**STATE OF MINNESOTA
MINNESOTA POLLUTION CONTROL AGENCY**

**IN THE MATTER OF THE DECISION
ON THE NEED FOR AN ENVIRONMENTAL
IMPACT STATEMENT FOR THE PROPOSED
NORTSHORE MINING COMPANY –
FURNACE 5 REACTIVATION PROJECT
LAKE COUNTY
SILVER BAY, MINNESOTA**

**FINDINGS OF FACT
CONCLUSIONS OF LAW
AND ORDER**

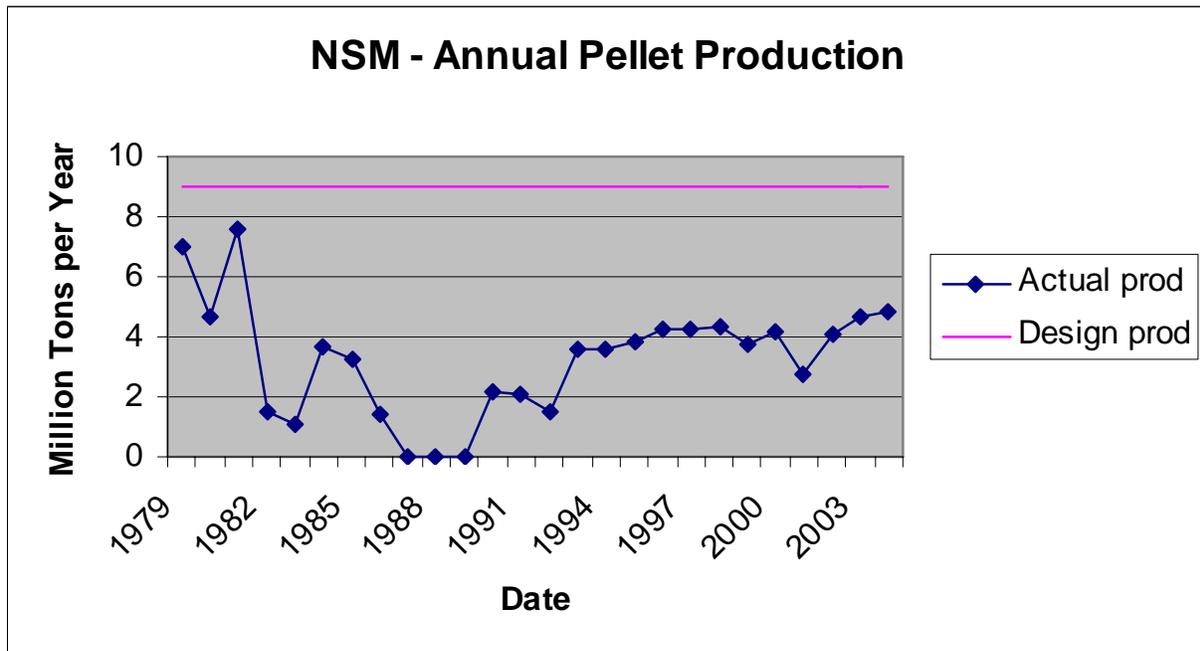
Comment 56-11: The commenter does not understand how low production of taconite pellets is related to NMC’s failure to remove adequate wastewater from the basin in the past 25 years and he states that increasing pollution to reduce pollution is not an acceptable strategy since impacts are cumulative.

Response: The consumption of water in the industrial process is directly correlated with production levels. Therefore, as production increases, the volume of water consumed in the process increases. The Mile Post 7 tailings basin was designed for full production (9.0 million tons of pellets per year). At 65 percent of full production (approximately 6 million tons per year), NMC has estimated that the taconite process consumes water at rates equal to the flow into the basin (process water plus precipitation). At production levels below 65 percent, water consumption becomes appreciably lower than the flow rates into the basin. Reduced production levels also reduce the volume of tailings available for ongoing construction of the required dams and dikes. The WWTP was designed to remove between 4.0 and 5.0 million gallons per day (MGD) of water from the basin. At the time of the design, it was believed that these discharge flow rates would maintain basin water levels, taking into account precipitation and estimated production levels. Below is a graph of the annual pellet production from 1979 through 2004, compared to the design, or full, production rate.

As can be seen in the graph, annual production each year has been below full production, and more importantly, has been below the 65 percent production value for all but two years during this time period. This time period also includes three years of no production. Therefore, there has been significant accumulation occurring within the basin that the current WWTP simply cannot remove under current conditions. Assuming production increases as proposed and remains at the proposed levels, the future

Ambient Concentration of Fibers Defined by Federal Court: Active Sites (F1 & F7) and St. Paul Sites 1978-80

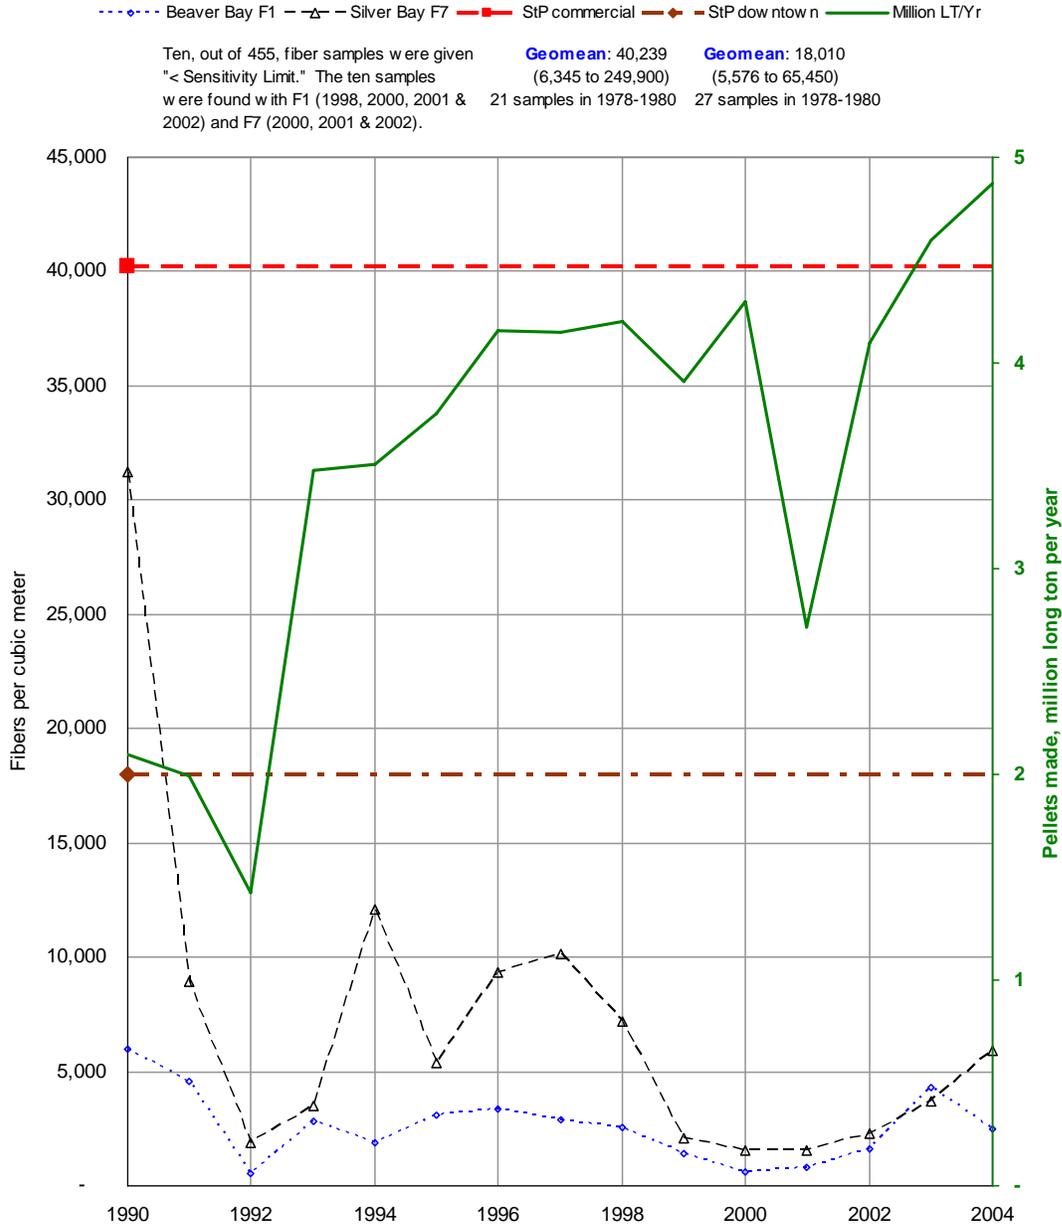
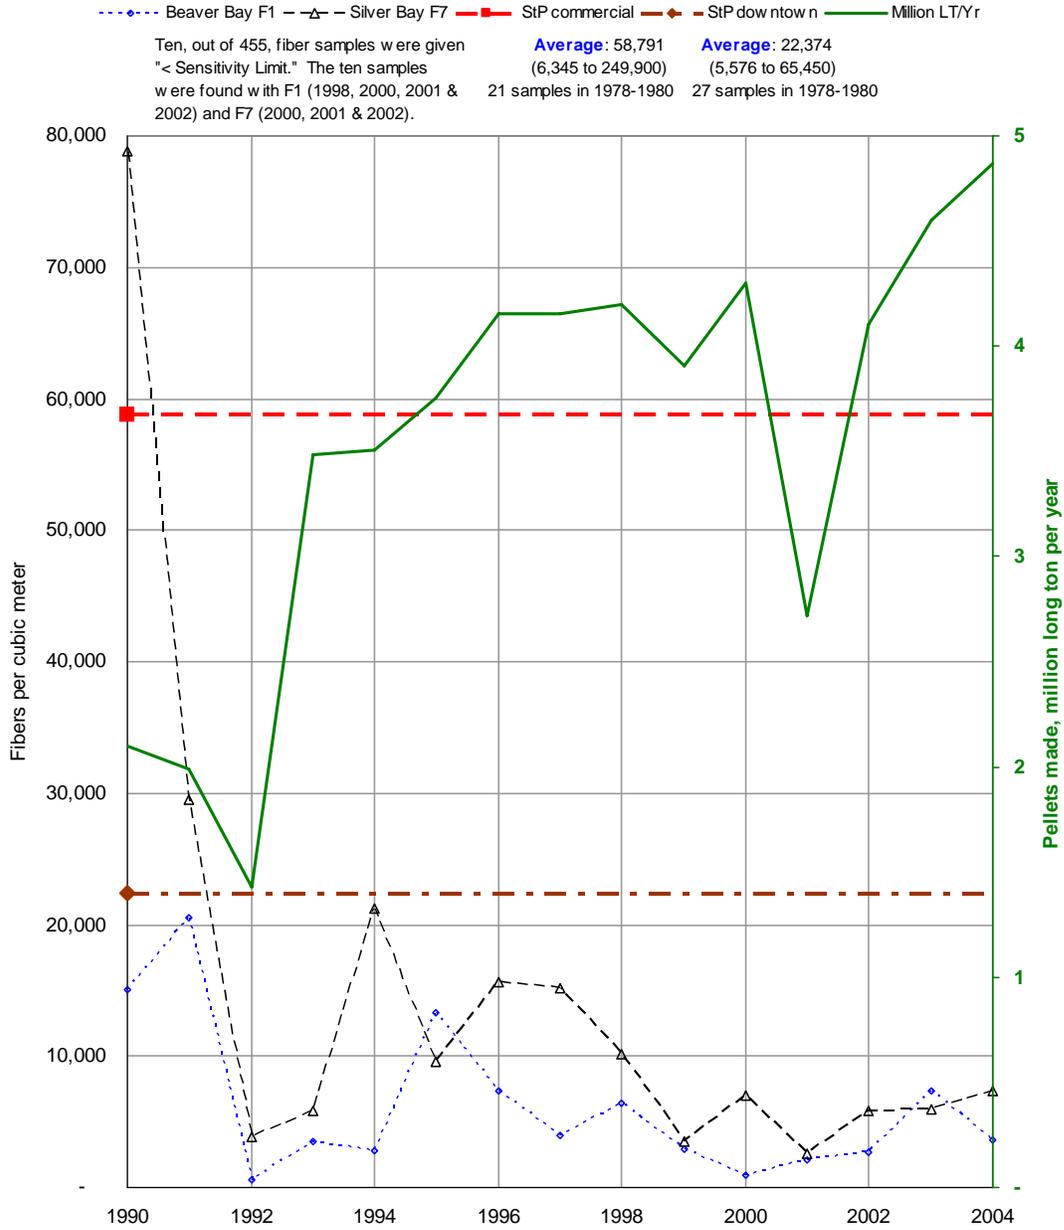
Comment 64-15: The commenter states that the original court ordered studies showed that the concentration of amphibole asbestos fibers in Silver Bay was as much as 9 times that in St. Paul in the 1970's. A court-ordered statistical analysis by Sanford Weisberg showed that the level of mining related amphibole asbestos fibers was significantly higher at four locations in Silver Bay than those in St. Paul.

Response: The commenter is correct if only the amphibole fiber levels are compared; however, the MPCA's fiber definition includes amphibole fibers and chrysotile fibers. Using the Sanford Weisberg results and comparing the sum of amphibole fibers and chrysotile, the current fiber levels in the Silver Bay area are below the past fiber levels (1978-1980 sampling data) in St. Paul. Below are graphs of ambient monitoring results from Silver Bay and Beaver Bay compared to two St. Paul locations (the first compares geometric means, the second compares arithmetic means). See Responses to Comments 56-26, 64-6, and 64-13.
